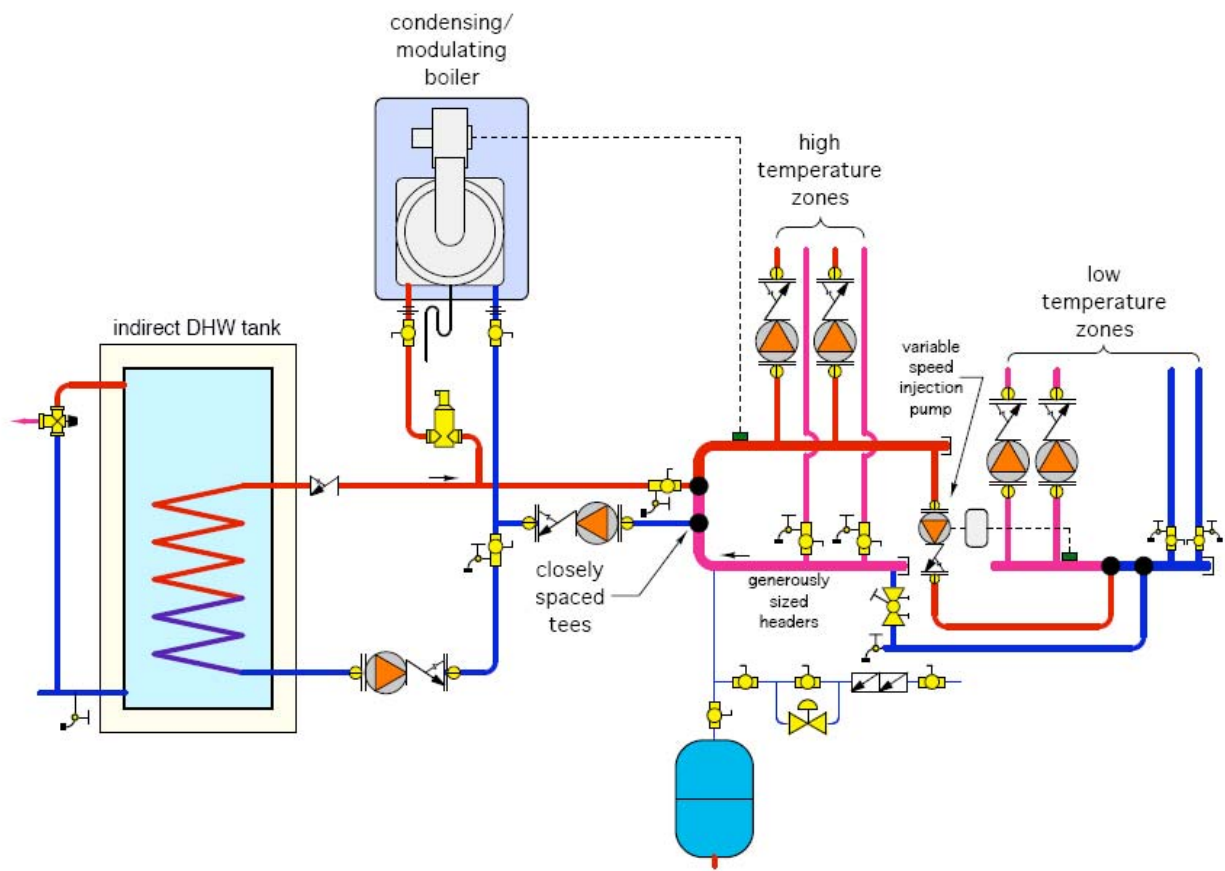
Although the installer's intention was to create a "primary loop," that's not what he ended up with. The two high-temperature zones are piped across the loop rather than into pairs of closely spaced tees. The "primary circulator" will also induce hot water migration into the higher temperature zones due to the head loss around the remainder of the "primary loop."

Another problem is the lack of a thermal trap, or check valve to stop heat migration through the injection risers when the injection pump is off, but the "primary circulator" is operating. Although the drop leg in the piping might constitute a "trap" of sorts, it will not stop heat migration into the injection risers.

There should also be purging valves on the return side of all zone circuits, and these valve need to be installed in the correct orientation. The glitch drawing shows them upside down on the return side of the high temperature zones.

There is no air separator in the glitch drawing. The fix drawing shows the air separator installed, so flow leaving the boiler passes through it in both space heating and domestic water heating modes.

The boiler's supply temperature sensor is mounted too close the closely spaced tees. In this position, the mixing between the incoming boiler water and system bypass water is not complete, and the temperature has not settled to the final blended value supplied to the distribution system. Ditto for the supply sensor of the injection mixing controller. The controls will respond to incorrect temperatures.

There is no need for the injection mixing controller to sense boiler return temperature with a condensing capable boiler.

Finally, a ball valve is not a good choice for balancing the return injection riser. A globe valve or other valve specifically intended for balancing should be used.

There is no need to create a primary loop in this system. Provided the headers are relatively short and generously sized (flow velocity less than 4 feet per second with all circulators running), the injection pump can be piped across the headers as shown in the fix drawing. However, be sure that a check valve is used in the injection circulator.
